# Special Standard PUD Zoning District

Project Name: Villages at Sterling Ranch PCD File No.: PUDSP-226

**DEVIATION REQUEST** (Attach diagrams, figures, and other documentation to clarify request)

#### PRIVATE ROAD (30' WIDE TRACT)

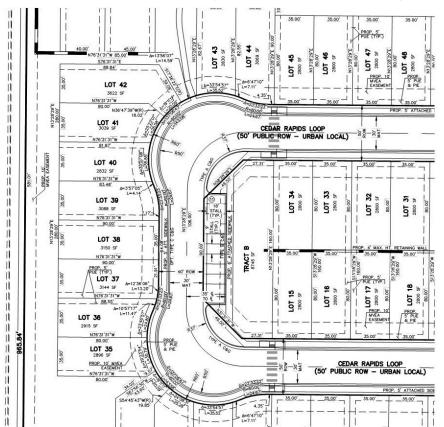
### 1. ECM 2.2.4.B.7 Special Standards:

#### Typical Urban Local (low volume) Road Section

Private roads functioning as an alley cannot meet all County public road standards, thus, the following represent the private road standards:

- 30' wide Private Road Tract owned and maintained by Metro. District
- Pavement mat = 22.0'
- Optional Type C C&G each side
- Curb Return radius = 15'
- · Pavement design per County stds.
- Design/Posted Speed = 20 mph
- No sidewalks or parking (Sidewalks provided to front of unit facing open space tract / Offstreet parking stalls provided throughout site)
- Reference City of Colorado Springs Residential Alley Standard for similar criteria (Fig. 20, City of C.S. Traffic Criteria Manual)

Fire Truck Turning Exhibit

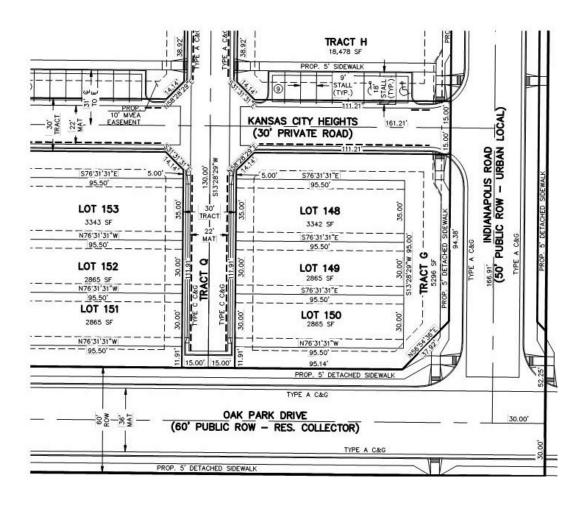
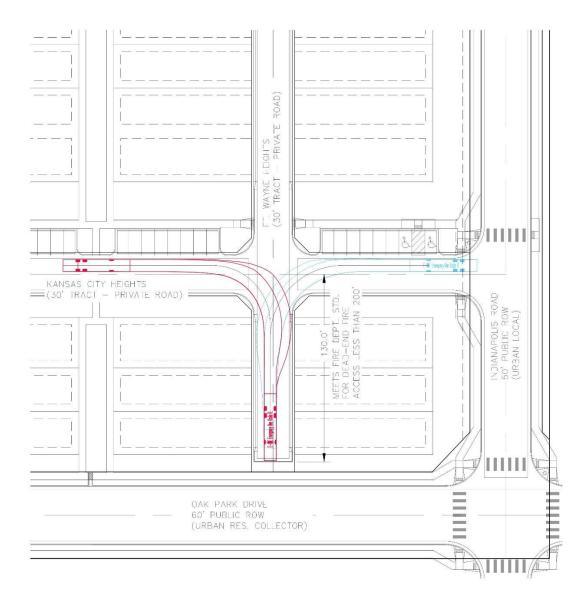
# 2. ECM 2.3.8.A Special Standards:

#### Hammerhead turnarounds are not permitted as permanent roadway terminations

This development includes access from private roads that provide turnaround ability for the residents and Fire District but not general public. The following are the design standards for the private roadways with hammerhead turnarounds:

- Max. distance for turnaround = 130'
- Adjacent private driveways provide turnaround ability for residents
- Meets Fire District turnaround standards and lot access with adjacent public ROW
- Curb Return Radius = 15'
- Pavement mat = 22' with opt. Type C C&G each side
- Reference Fire truck turning exhibit below (Meets Fire Dept. std. for dead-end road)

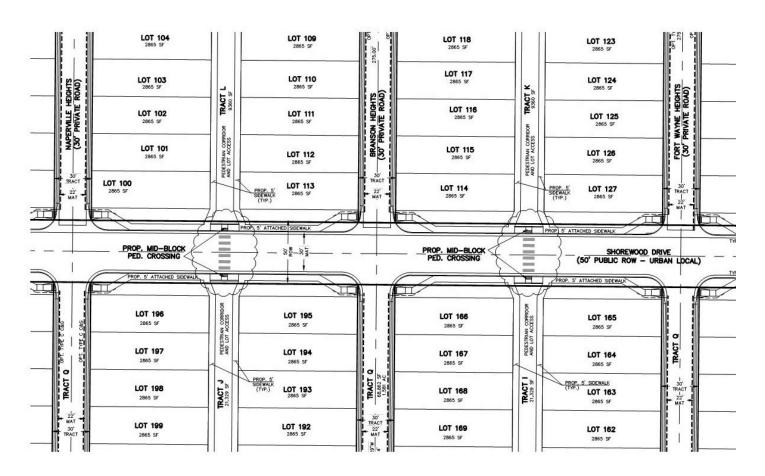
# 3. ECM 2.5.2.C.2 Special Standards:

#### Accessible curb ramps - 4-way intersections required ped. Ramps on all four corners

This development includes two 4-way intersections where private streets intersect public streets, however, there are no sidewalks within the private streets as they function more like an alley. Therefore, crossing of the public street at these intersections may not be the best design from a pedestrian standpoint. The following special standards are proposed for these specific intersections:

- The private roads function more as an alley with no sidewalks either side. This rear loaded
  product provides sidewalks at the front of the units within open space tracts. Thus, the need
  for sidewalk crossings at these private street intersections is mainly to cross the private
  roadway and ped ramps are provided for this at each intersection.
- Mid-block pedestrian crossings of the public roadway are proposed to align with the
  pedestrian corridors within the open space tracts that provide sidewalk connection to the front
  of the units.
- The distance between the proposed mid-block ped. ramp crossings of the public road is only 250', similar to the County std. intersection distance.
- Additional signage and striping will be added for these two mid-block crossings.
